IDAP REPORT

Property:	1 The Causeway, Strathfield South Lot 42 Sec 1 DP 407 DA2020/229
Proposal:	Demolition of existing structures and construction of a two (2) storey dwelling with basement level, outbuilding and swimming pool.
Applicant:	Design link Australia Pty Ltd
Owner:	S Melham / J Sassine
Date of lodgement:	16 December 2020
Notification period:	13 January 2021 to 29 January 2021
Submissions received:	Nil
Assessment officer:	P Santos
Estimated cost of works:	\$1,355,107.00
Zoning:	R2-Low Density Residential - SLEP 2012
Heritage:	N/A
Flood affected:	Yes
RECOMMENDATION OF OFFICER:	APPROVAL

Figure 17. Extract of the marked-up first proposed basement plan provided by council's Traffic Manager.

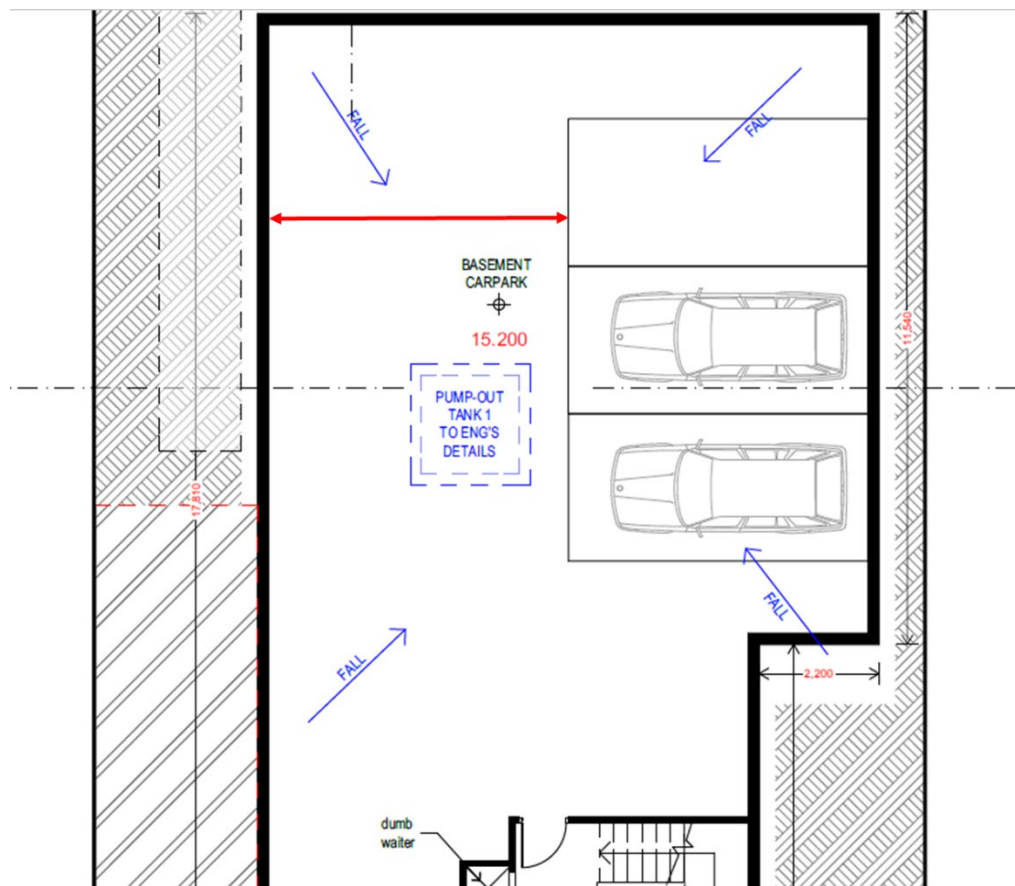
"The SEE nominates 3 parking spaces in the basement. The aisle width at the parking spaces as highlighted in red does not conform to the minimum requirement of 5.8m for Class 1A parking facility. This may require vehicles to undertake more than 3-point turns to gain access to/from this space."

"...a minimum 1m x 1m splay shall be provided at the vehicular access driveway, to maintain sight distances for pedestrians and motorists. The remaining areas created by providing a splay adjacent to a road intersection or driveway entrance must be landscaped with low-growing vegetation."

"...the driveway width at the property boundary shall not exceed 3m."

Comments above were relayed to the applicant through the additional information request letter dated 09 March 2021. The applicant provided a redesigned basement floor plan, taking into consideration also the Planner's request to reduce the footprint of basement.

The new basement floor plan was referred back to council's Traffic Manager who offered no objection to the proposal, subject to the imposition of the provided conditions of consent.

Figure 18. Marked-up image of the most recent proposed basement plan. Red area to be deleted, shaded area in grey to be added in the FSR calculation.

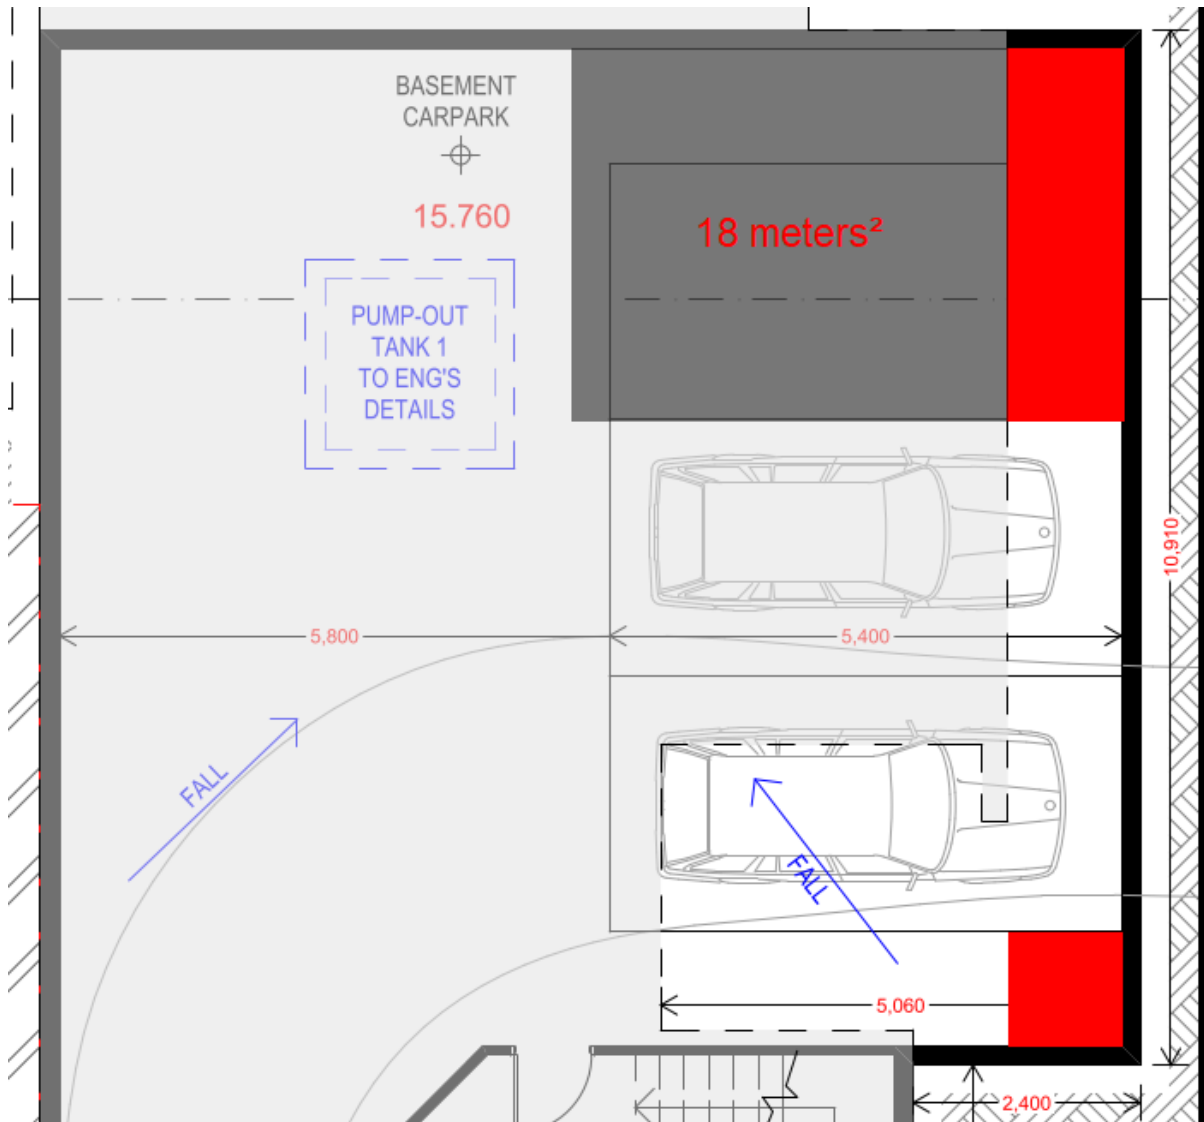
Given the above definition of GFA, the third parking space will be included in the calculation of FSR. Moreover, due to the excessive excavation that will result to the eastern part of the basement to be outside the footprint of the ground floor, it will be required that the eastern portion of the supposed third parking area and the south-eastern corner of the parking spaces to have a greater setback from the secondary street. More on this in the cut and fill assessment of the proposed development.

Taking the above information into consideration, 18m² of the basement will be added into the calculation of GFA, resulting to a total FSR of 0.62:1 (356.58m²), which satisfies the FSR development standard.

To limit the amount of excavation adjacent to the secondary street boundary, the north-eastern and south-eastern sections of the proposed basement, as marked in red in Figure 18, are to be deleted. It is acknowledged that the parking spaces and the area behind, needed for manoeuvring, will need to satisfy the minimum requirements under the Australian Standards. As such, the area that is within the secondary street setback, outside the footprint of the ground floor, for the purposes of the car parking spaces, is acceptable in merit and can remain.

Figure 19. Extract of the southern elevation with the subject parts of the front fence outlined in red.

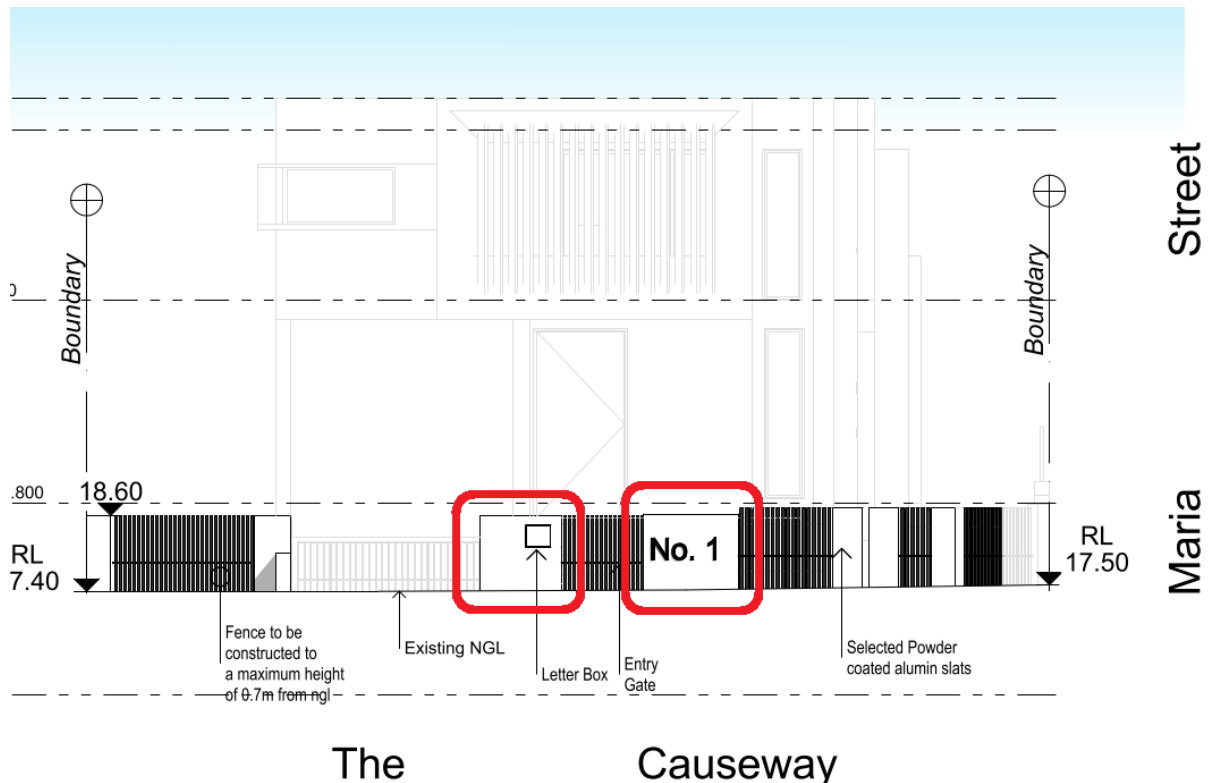
The SCDCP 2005 requires that no solid component of the front fence shall be higher than 0.7m, with the exception of brick piers. See Figure 19 for clarity.

The outlined sections of the proposed front fence in Figure 19 does not satisfy the requirements of the SCDP 2005. However, it is considered that these sections are minimal and will be features of the proposed fencing. No adverse amenity or environmental impact is envisaged to occur should the front fence be supported and constructed. Further, council is satisfied that the relevant objectives of the DCP are satisfied.

Figure 20. Extract of the proposed basement floor plan. Yellow shows the area that is outside the ground floor footprint.

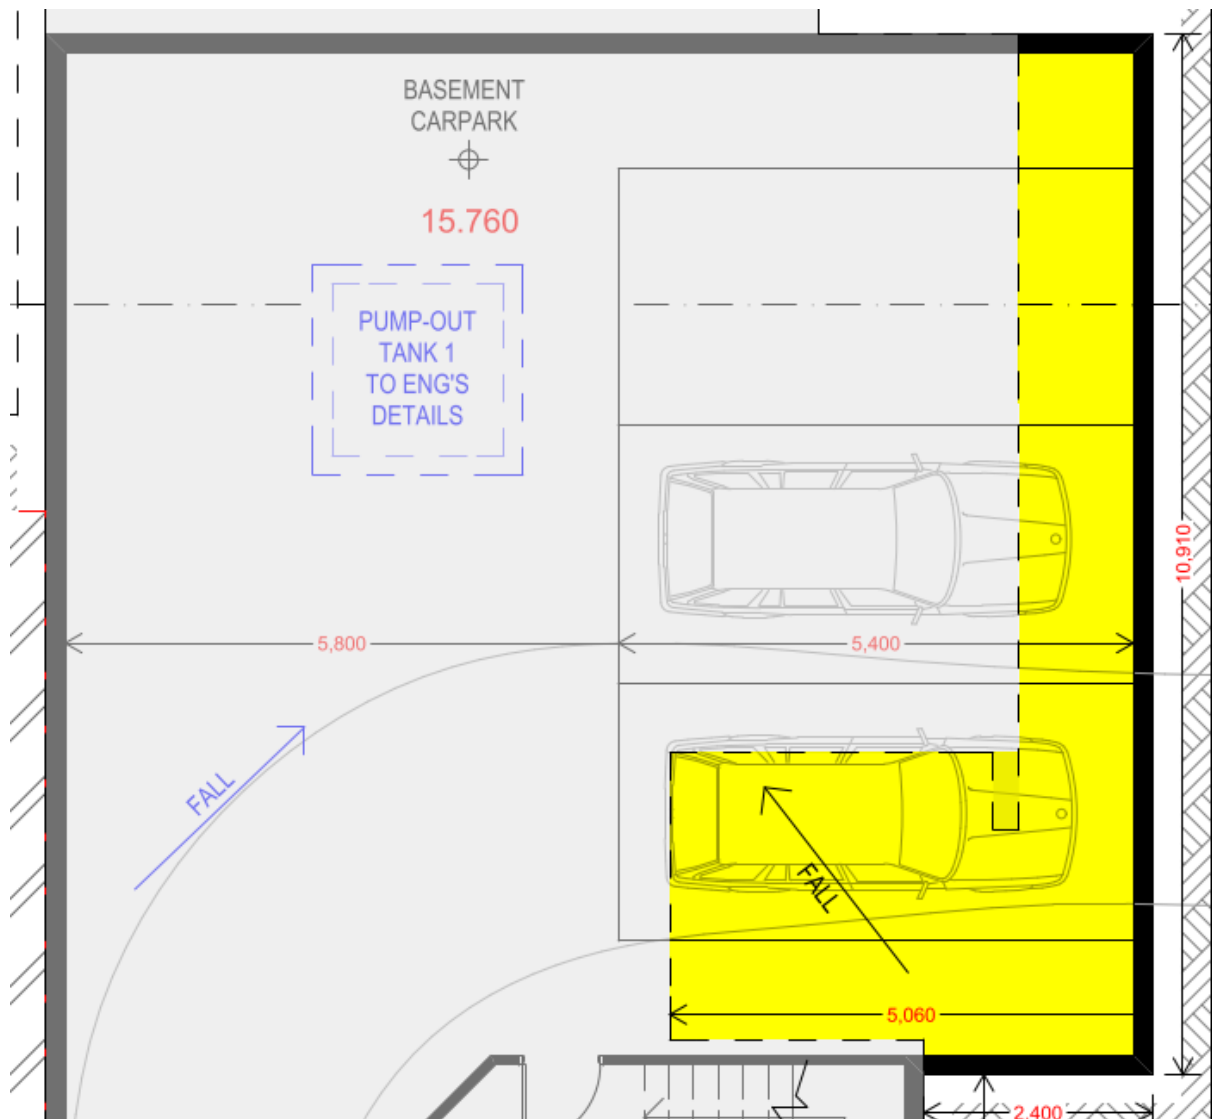
As mentioned elsewhere in the report, the proposed basement is outside the footprint of the ground floor. For completeness, Figure 20 below highlights the area in the basement that is not within the boundaries of the ground floor external walls.

The proposed basement does not satisfy the SCDGP 2005 requirements. In particular, Part A Clause 8.2.3.1 where it is required that the maximum area of a basement shall be limited to and contained within the footprint of the dwelling at ground level, and Clause 9.2.5 where it is required to have all areas of excavation be setback from property boundaries in accordance with the building setback controls.

Conditions of consent are imposed to ensure compliance with the above information.
